## SAFETY ADVISORY # 17-293

### Avalanche 370 Slide Ram

**Models Included:** 2016 - 2018 Avalanche, Model 370RD

#### Step 1

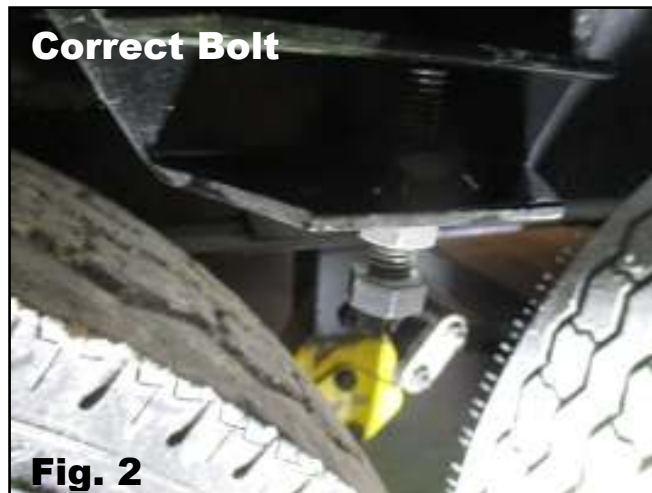
Keystone is conducting a voluntary RECALL notification campaign in accordance with the National Highway Transportation and Safety Act. It has been decided the vehicles in this recall population may have an adjustment bolt for the kitchen slide that can come into contact with the tire. The adjustment bolt and tires touching during travel may lead to an increased risk of loss of control and vehicle crash.

Locate the kitchen slide ram at the off door side front tire.

If there is less than 2 3/4" of space between the bolt head and tire replace the bolt with the part number provided above. See Figure 1 for incorrect bolt and Figure 2 for correct bolt. Using a ratchet and 3/4" socket, remove the existing bolt. Start the new bolt by hand and finish with the ratchet, install the bolt firmly against the adjustment plate.
